SEABROOK STATION
Engineering Office:
1671 Worcester Road
Framingham, Massachusetts 01701
(617) - 872 - 8100

January 28, 1983

SBN-439
T.F. B7.1.2

Subject: Additional Information for the Locked Rotor/Shaft Break Event:
(SRP 15.3.3; RAI 440.89 and 440.127; Reactor Systems Branch)

FIGURE 1

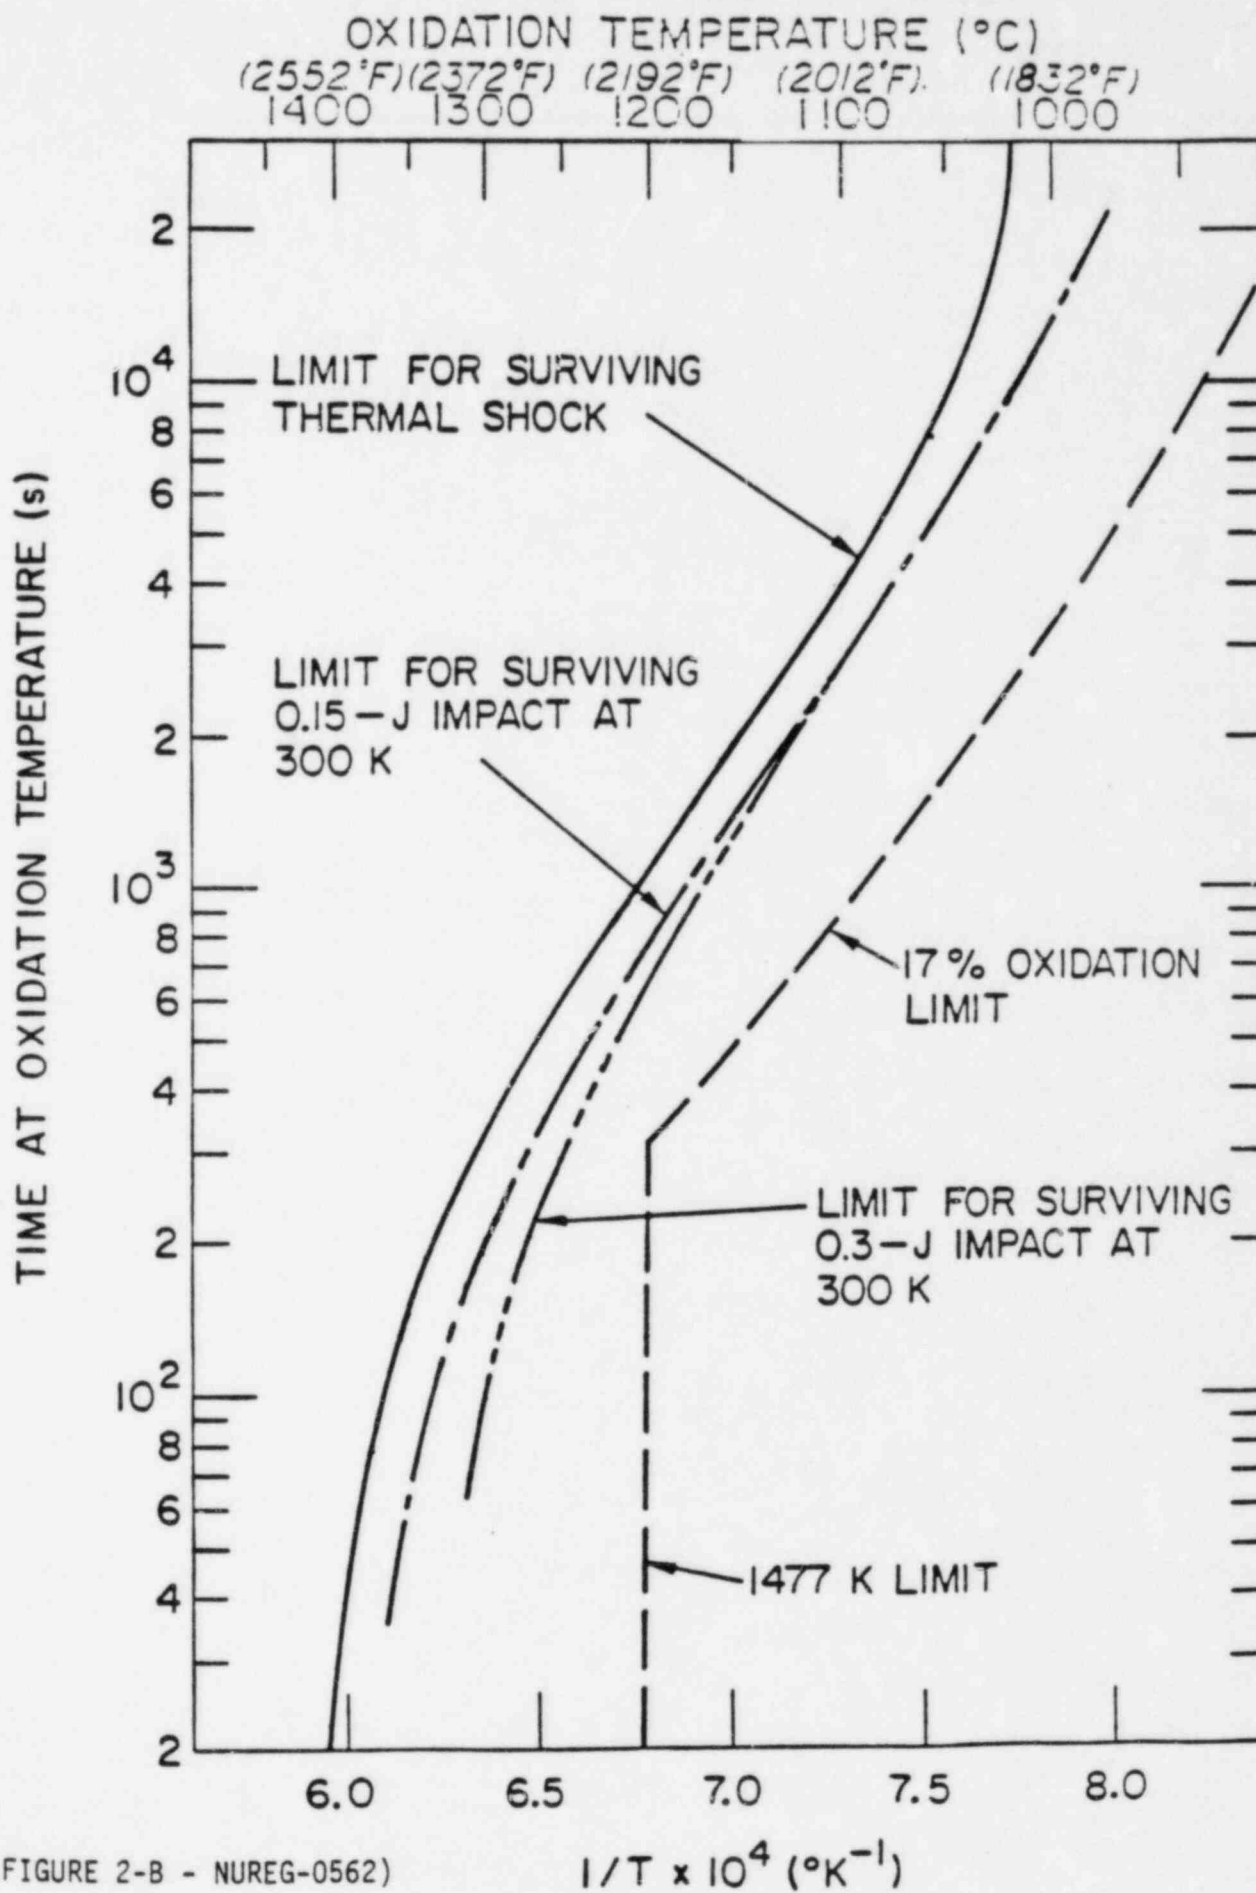
Figure 1 is based on the results of out-of-pile Zircaloy-steam oxidation tests of Kassner and Chung et.al. of ANL. In these tests the cladding was subjected to a rapid heatup, an isothermal soak and a rapid cooldown. The ability of the oxidized cladding to withstand the thermal shock of the quench and/or shock of a subsequent sharp impact was then determined. The data were for a .6 mm thick cladding (W 17x17 cladding thickness is .0225" = .57 mm). The limit line for surviving a .3 Joule impact at 300°K (80°F) is given. Studies showed that if the oxidized cladding can withstand this, then the cladding is still tough enough to withstand both operating stresses when at working temperatures and the mechanical stresses of handling when at room temperatures. The line for surviving thermal shock corresponds to the quenching of the hot oxidized cladding. This line is roughly equivalent to a limit line for surviving at .03 Joule impact at 300°K (80°F). The 17% oxidation and 1477°K (2200°F) lines correspond to NRC imposed LOCA limits.

W maintains that as long as the locked rotor transient results in a time-at-temperature below the oxidized clad failure limit lines in Figures 1 and 2, no fuel failure will result. This does not replace the need to verify by means of peak clad temperature analysis that the fuel maintains a coolable geometry for the locked rotor accident.

FIGURE 2

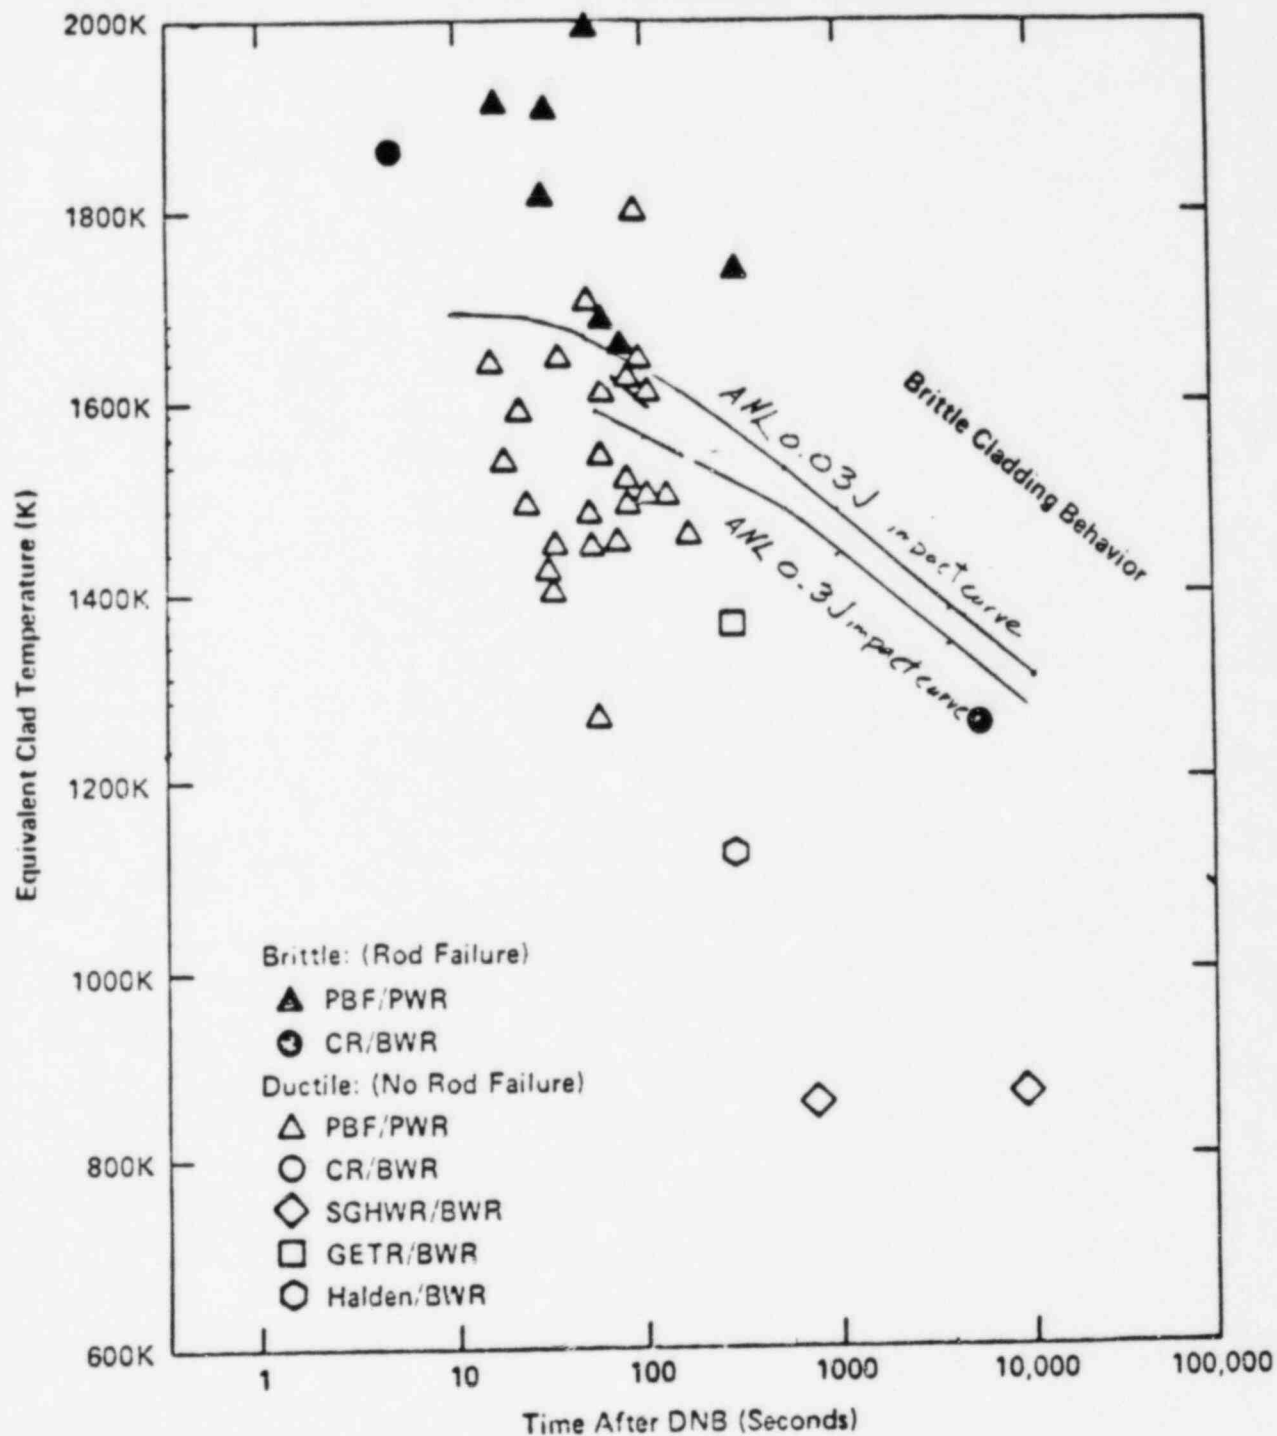
Figure 2 gives the results of inpile test data of fuel rods operated under DNB or dryout conditions. The two limit lines from Figure 1 describing the ability of the oxidized clads to withstand thermal shock or impact are also plotted. Comparisons of these lines to the data indicates that the limit lines based on out-of-pile data are effectively the same as those based on inpile data.

FIGURE 3

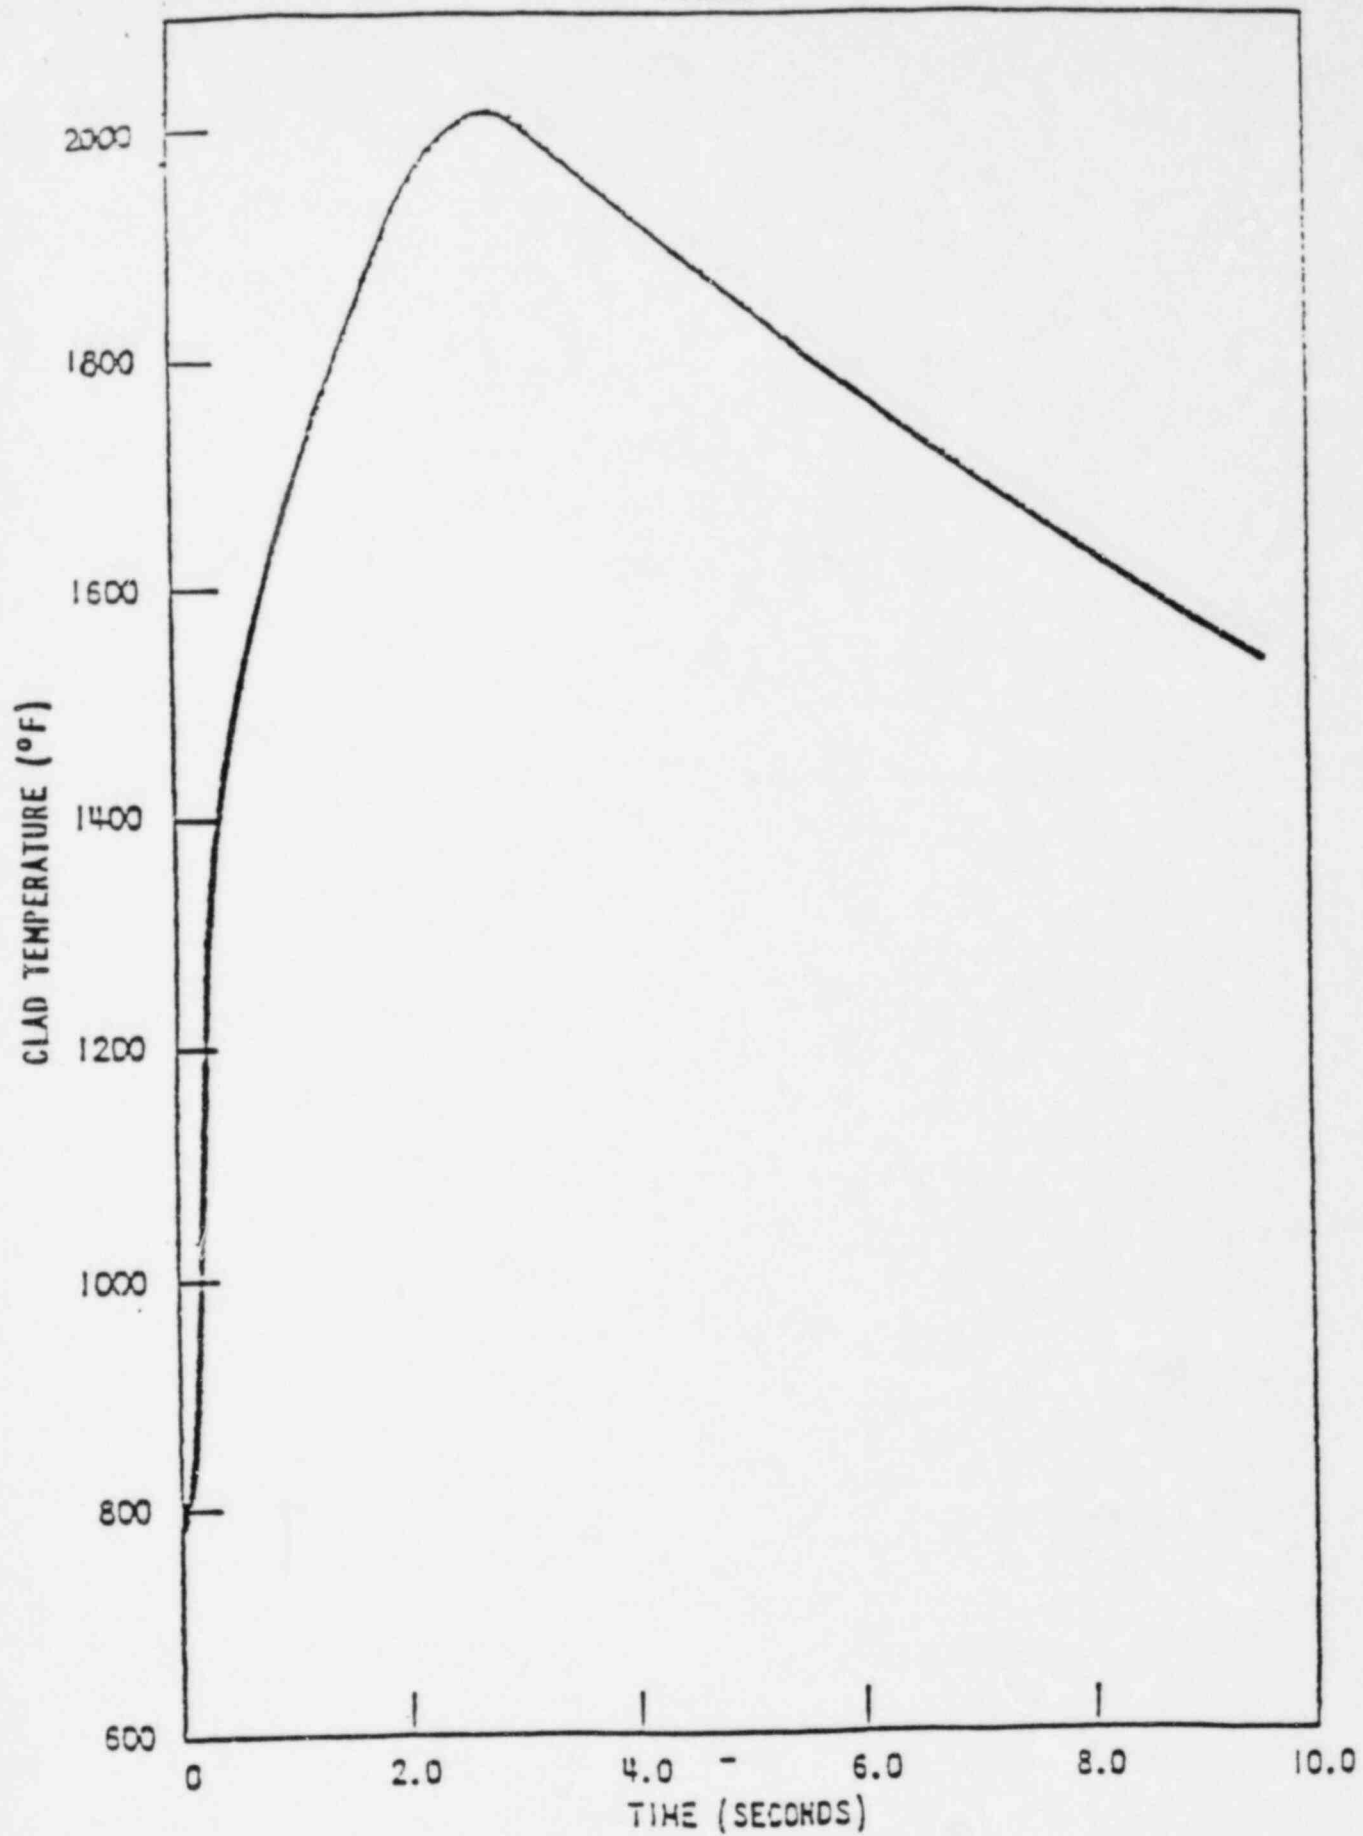
The melting point⁽¹⁾ of Zircaloy-2 and -4 is 3360°F. This is well above any clad temperatures conservatively estimated to occur during LR for a typical plant (Figure 3). Thus, LR does not result in conditions in which clad melting is a clad failure mechanism.

Figure 3 gives the W fuel clad temperature as a function of time for a typical worst type LR accident. The temperatures were calculated under conservative assumptions and assumed that the rod was in film boiling. Thus, if it were conservatively assumed that the clad temperature remains at 2000°F (1366°K, $.00073^{\circ}\text{K}^{-1}$) for 10 seconds, it is seen that this gives a point on Figures 1 and 2 well below the limit lines. Thus the limiting rod in DNB during a LR accident will have a large margin to withstand both the temperature transient (heatup and quench) that occurs during the accident and the handling of the rod after the accident.
